Access Compliance Report Public Rights-of-Way (Curb Ramps)

Main Street: **ENDRY_ST** Cross Street: **CANTON_AVE** Location: **NE**

ADA ID: **RPAT210916123341** Ramp Type: **Type 4 - Parallel** Initial Pass/Fail: **Pass** Overall Compliance: **No** Severity Score: **4**

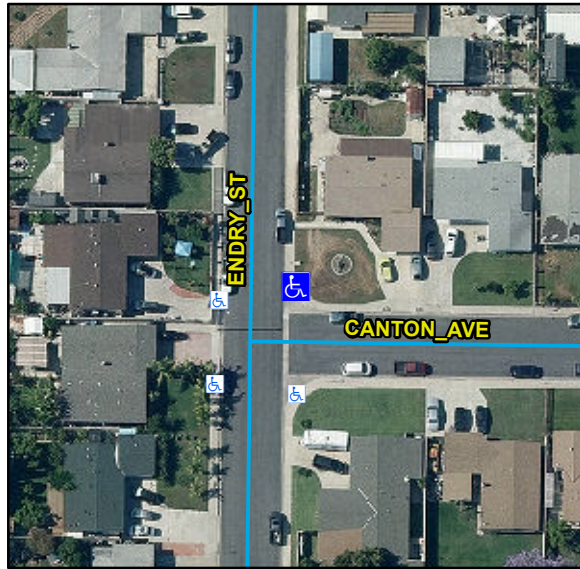
Compliance	Description	Data	Compliance	Description	Data
N/A	Ramp Length LT (in)	71	N/A	Ramp Length RT (in)	70
Yes	Ramp Width LT (in)	52	Yes	Ramp Width RT (in)	52
Yes	Ramp Run Slope LT (%)	6.1	Yes	Ramp Run Slope RT (%)	5.5
Yes	Ramp Cross Slope LT (%)	0.2	Yes	Ramp Cross Slope RT (%)	0
N/A	Landing Present	Yes	Yes	DWS Provided	Yes
N/A	Landing Length (in)	52	Yes	DWS Contrast	Yes
No	Landing Width (in)	46	Yes	DWS Length (in)	36
Yes	Landing Run Slope (%)	0.2	Yes	DWS Full Width	Yes
Yes	Landing Cross Slope (%)	1.8		DWS Offset Type	Single
N/A	Landing Movement Obstructed?	No	Yes	DWS Offset Left (in)	0
	Landing Movement Type	Curb	Yes	DWS Offset Right (in)	N/A
N/A	Landing Shared	No			
N/A	Clear Space	Yes			
N/A	Clear Space To Crosswalk (in)	48			
N/A	Marked Crosswalk 1	No	N/A	Marked Crosswalk 2	No
	Crossing 1 Direction	W		Crossing 2 Direction	S
	Marked Crosswalk 1 Width (in)	N/A		Marked Crosswalk 2 Width (in)	N/A
N/A	Ramp Inside Crosswalk 1	N/A	N/A	Ramp Inside Crosswalk 2	N/A

Remove & Replace Landing.
